**RE: Letter of Comment Concurrent Application**

**PA2019/0337**

**Section 3321 (50) Secrett Road, Knuckey Lagoon, Hundred of Bagot  
Rezone from Zone R (Rural) to Zone RL (Rural Living)  
and Subdivide to Create Three Lots**

CONCEPT SUBDIVISION

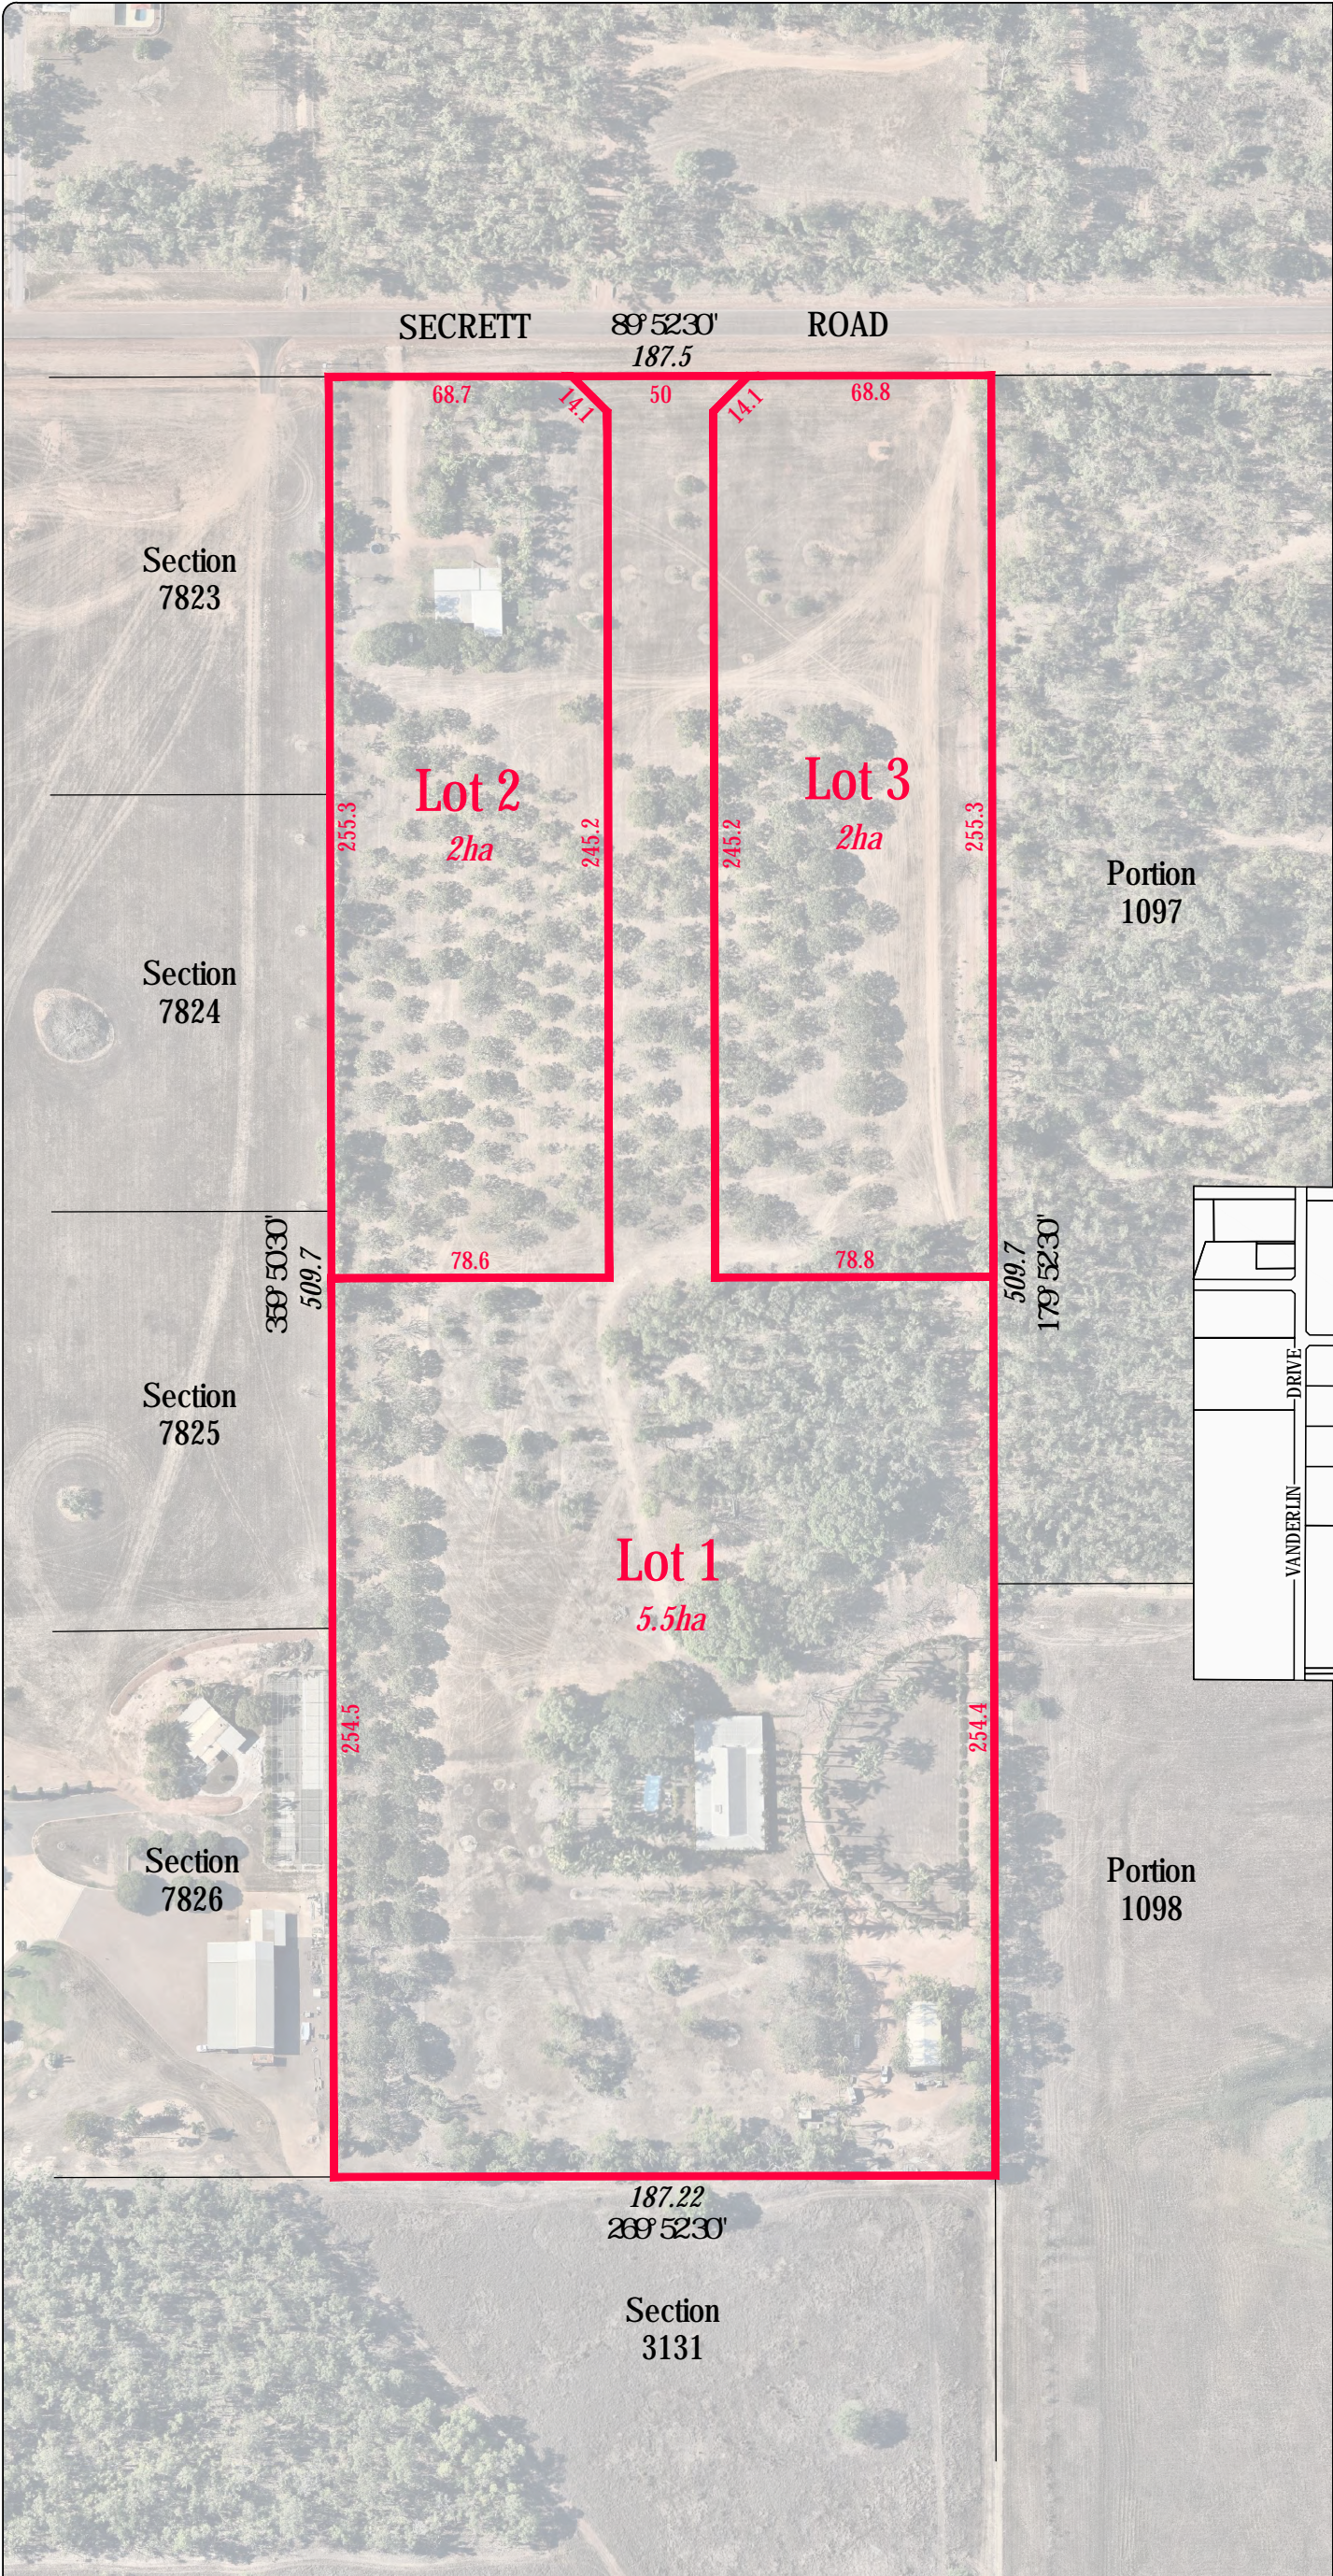
- a) The subject site is suitable to rezone to allow for smaller lot sizes due to its location adjacent other lots in Zone RL (Rural Living) and its proximity to urban uses along Vanderlin Drive.
- b) The proposed plan of subdivision is suitable to meet minimum lot sizes required for Zone RL (Rural Living), and, given the width of the proposed battleaxe for Lot 1, provides well for future subdivision opportunities.

- a) Prior to the endorsement of plans and prior to the commencement of works, a schematic plan demonstrating the on-site collection of stormwater and its discharge into Litchfield Council's stormwater drainage system shall be submitted to and approved by Litchfield Council.
